February 23, 1996  
Project 320-162.1A

Re: Work Plan Addendum  
Former Signal Station 800  
800 Center Street  
Oakland, California 94607

SITE MAP

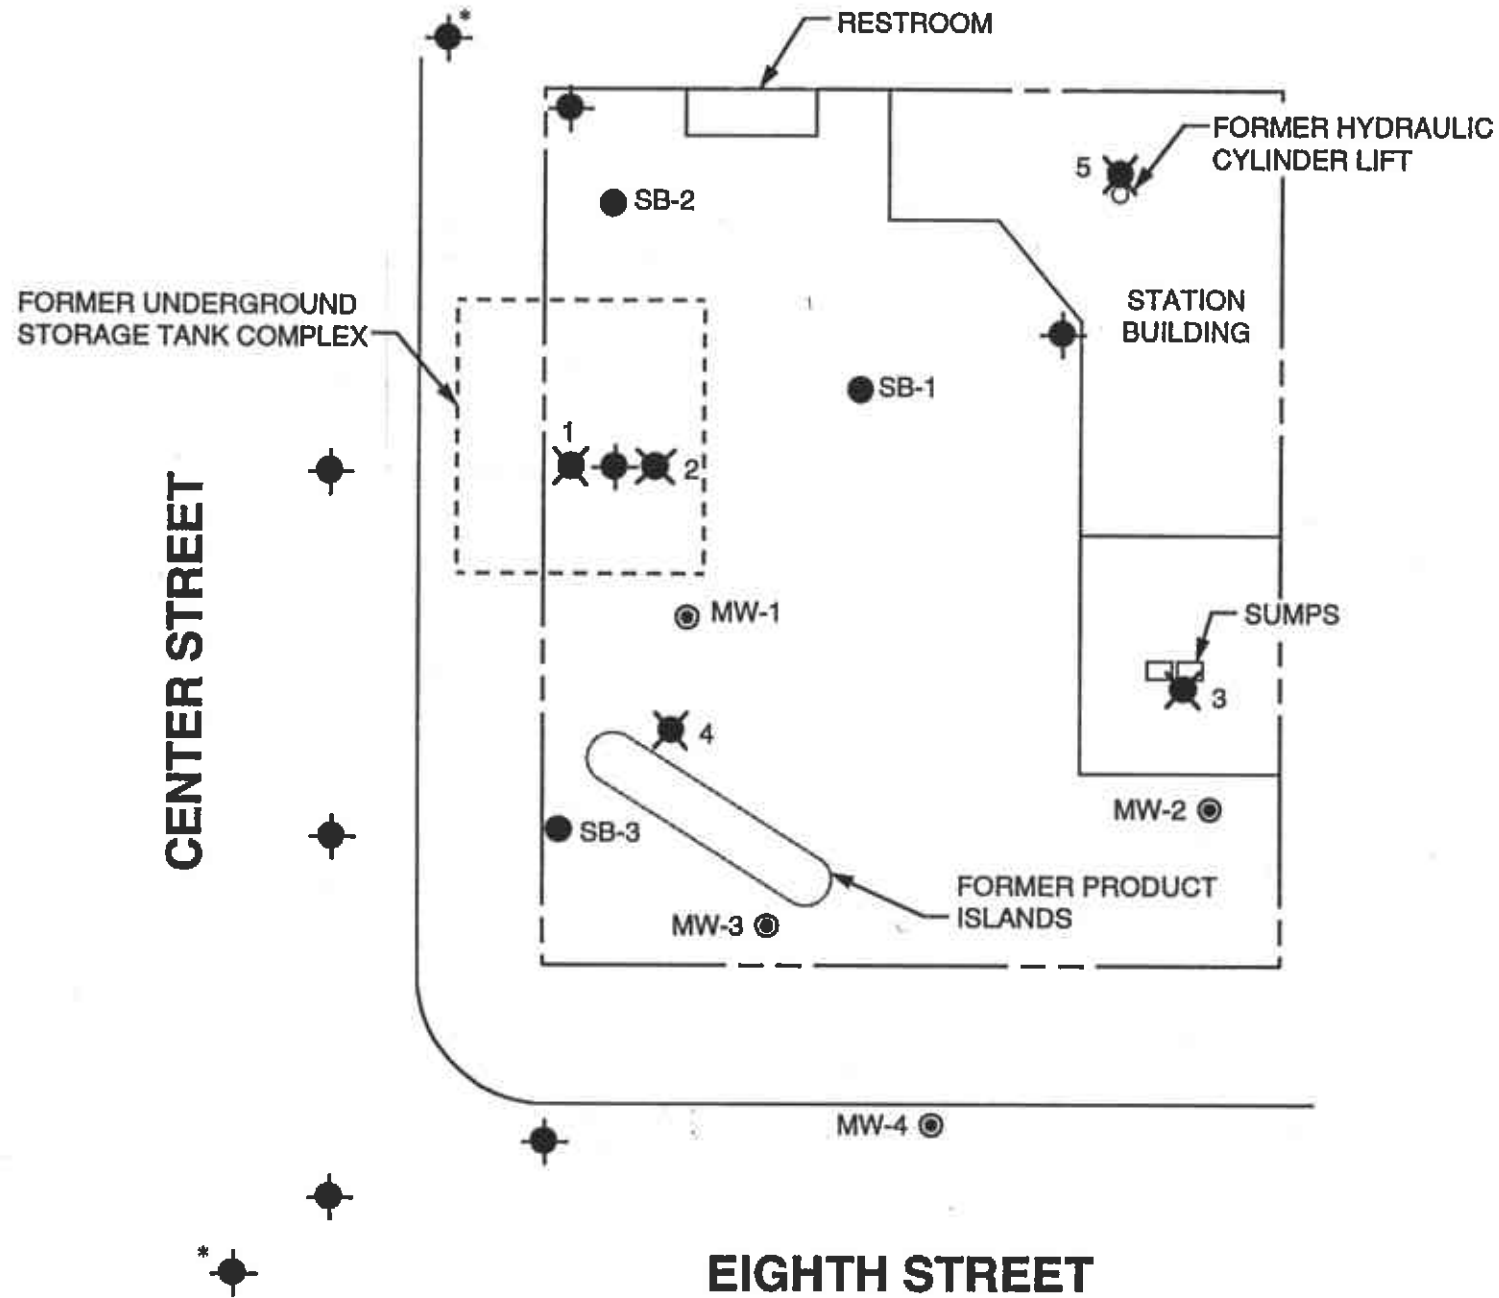
Upon review the workplan, Ms. Jennifer Eberle requested that one of the well locations located at the corner of Center and Eighth Streets be moved to the east. An additional boring in the vicinity of the former underground storage tanks will be drilled in order to vertically define soil contamination near the center of the hydrocarbon plume. Figure 1 presents a site map with the modified soil boring locations.
